# Access Compliance Report

## Public Rights-of-Way

### (Curb Ramps)

Intersection ID: 44267	Main Street: BRITTNI_DAYLE_DR	Cross Street: ISAAC_HUNTER_DR	Location: NW
ADA ID: 380ED0E9378B	Ramp Type: BlendTrans1	Initial Pass/Fail: Fail	Overall Compliance: No
Severity Score: 8.75			
Codes/Mitigation Info/Possible Solution		Field Measurements/Component Compliance

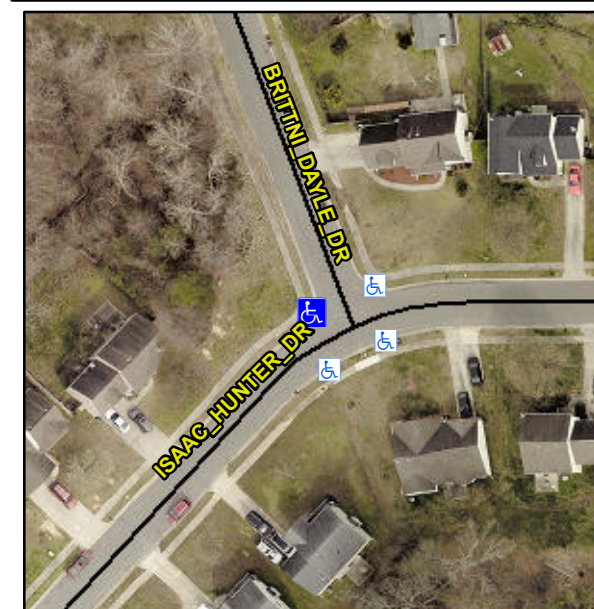
**Not Found, R304.5.1**

Compliance	Description	Data	Compliance	Description	Data
N/A	Ramp Length (in)	50.0	Yes	BlendTrans Slope (%)	3.0
No	Ramp Width (in)	39.0	Yes	BlendTrans XSlope (%)	1.3
N/A	Flare Type LT	N/A	N/A	Flare Type RT	N/A
N/A	Flare Slope LT (%)	N/A	N/A	Flare Slope RT (%)	N/A
N/A	Flare Traversable LT?	N/A	N/A	Flare Traversable RT?	N/A
N/A	Landing Length (in)	N/A	N/A	DWS Provided?	N/A
N/A	Landing Width (in)	N/A	N/A	DWS Contrast?	N/A
N/A	Landing Slope (%)	N/A	N/A	DWS Length (in)	N/A
N/A	Landing X Slope (%)	N/A	N/A	DWS Full Width?	N/A
N/A	Landing Curb? (Y/N)	N/A	N/A	DWS Offset (in)	N/A
N/A	Shared Landing?	N/A			
N/A	Gutter Ponding?	N/A	N/A	Gutter Slope (%)	N/A
N/A	Gutter Lip Ht (in)	N/A	N/A	Gutter X Slope (%)	N/A
N/A	Painted X Walk1?	No	N/A	Painted X Walk2?	No
	X Walk 1 Direction	To S		X Walk 2 Direction	To E
	X Walk 1 Width (in)	N/A		X Walk 2 Width (in)	N/A
	X Walk 1 Slope (%)	4.8		X Walk 2 Slope (%)	1.7
	X Walk 1 X Slope (%)	1.7		X Walk 2 X Slope (%)	3.7

N/A	Ramp inside XWalk1?	N/A	N/A	Ramp inside XWalk2?	N/A
	Road Slope (%)	1.6		Clear Space?	N/A
	Road X Slope (%)	4.2	N/A	Clear Space to XWalk (in)	N/A
N/A	Any Obstructions?	N/A	N/A	Storm Grate/Utility Hazard?	N/A
	Obstruction Type			Storm Grate/Utility Type	
		N/A			N/A
			Yes	Surface Condition? (G/P)	Good
			No	Curb Slope (%)	8.8

**Remove & Replace Curb Ramp With Two New Directional Ramps or Equivalent.**
